UNITED STATES PATENT AND TRADEMARK OFFICE

APPLICATION NO.	FILING DATE	FIRST NAMED INVENTOR	ATTORNEY DOCKET NO.	CONFIRMATION NO.
10/643,406	08/19/2003	Wen Fei Yu	10541-1850	3454

Office Action Summary

DETAILED ACTION

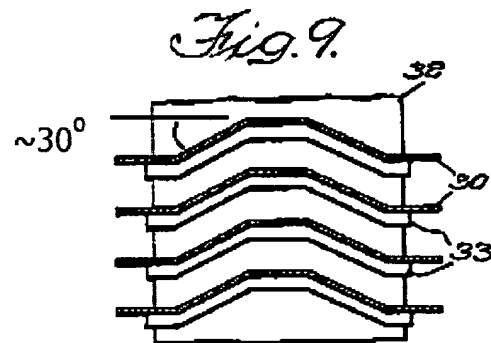
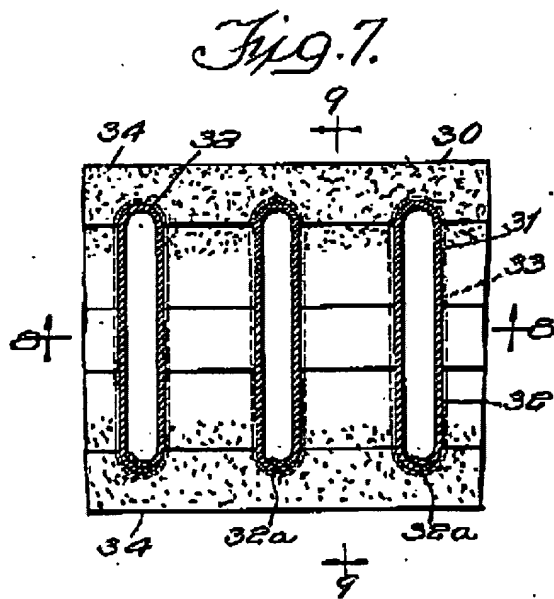
Regarding applicant's remarks with respect to Modine ('470), Modine ('521) or Hughes et al, the Examiner agrees the references primarily disclose fins engaged with tubes. As stated

throughout the entire prosecution, the recitation of a “header” does not structurally define over the fins of the respective prior art references. Applicant has not addressed this issue.

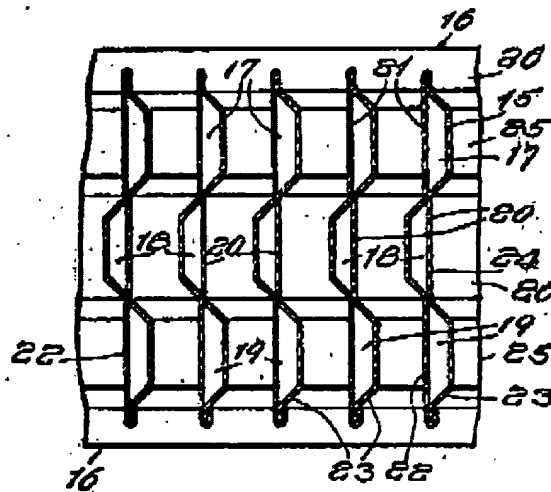
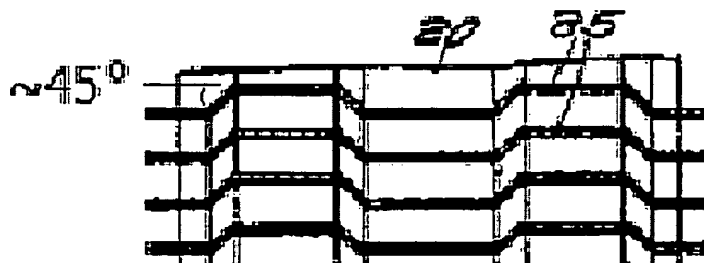
The amended claim limitations are present in each and every prior art reference as follows.

Figure 7 of Modine (1,730,470) discloses a structure having a substantially planar base portion extending laterally (top to bottom) defining a width and longitudinally (left to right) defining a length. Along site line 9-9 of Figure 7, Figure 9 discloses a pair of step portions extending longitudinally along a respective side of the base portion and extending laterally at an angle of about 30 degrees as a straight segment. The recitation of a “header” does not structurally define over the fins of Modine (1,730,470).
